Access Compliance Report

Public Rights-of-Way (Curb Ramps)

Intersection ID: 2501	Main Street: BENTGRASS_RUN_DR	Cross Street: WHISTLER'S_CHASE_DR	Location: S
ADA ID: 4A21C6EE06B9	Ramp Type: PerpDiag	Initial Pass/Fail: Fail	Overall Compliance: No
		Severity Score: 10

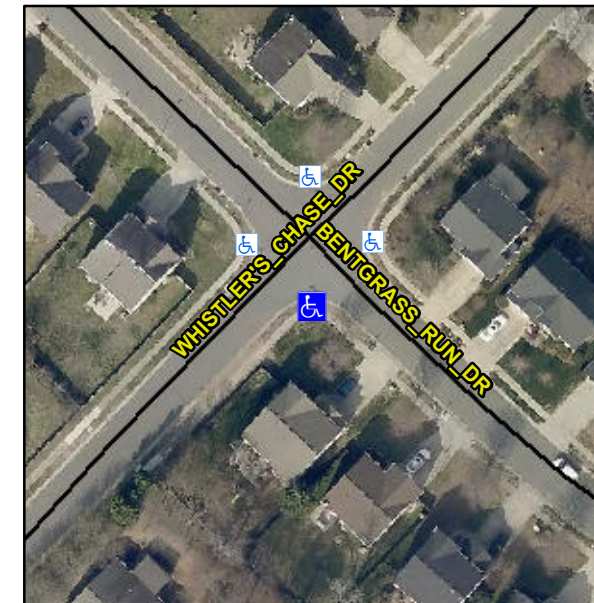
R304.5.1, R304.5.3

Compliance	Description	Data	Compliance	Description	Data
N/A	Ramp Length (in)	47.0	Yes	Ramp Slope (%)	6.2
No	Ramp Width (in)	41.0	No	Ramp XSlope (%)	3.5
N/A	Flare Type LT	N/A	N/A	Flare Type RT	N/A
N/A	Flare Slope LT (%)	N/A	N/A	Flare Slope RT (%)	N/A
N/A	Flare Traversable LT?	N/A	N/A	Flare Traversable RT?	N/A
N/A	Landing Length (in)	N/A	N/A	DWS Provided?	N/A
N/A	Landing Width (in)	N/A	N/A	DWS Contrast?	N/A
N/A	Landing Slope (%)	N/A	N/A	DWS Length (in)	N/A
N/A	Landing X Slope (%)	N/A	N/A	DWS Full Width?	N/A
N/A	Landing Curb? (Y/N)	N/A	N/A	DWS Offset (in)	N/A
N/A	Shared Landing?	N/A			
N/A	Gutter Ponding?	N/A	N/A	Gutter Slope (%)	N/A
N/A	Gutter Lip Ht (in)	N/A	N/A	Gutter X Slope (%)	N/A
N/A	Painted X Walk1?	No	N/A	Painted X Walk2?	No
	X Walk 1 Direction	To NE		X Walk 2 Direction	To NW
N/A	X Walk 1 Width (in)	N/A	N/A	X Walk 2 Width (in)	N/A
	X Walk 1 Slope (%)	2.9		X Walk 2 Slope (%)	3.9
	X Walk 1 X Slope (%)	4.8		X Walk 2 X Slope (%)	1.8

Remove & Replace Curb Ramp With Two New Directional Ramps or Equivalent.
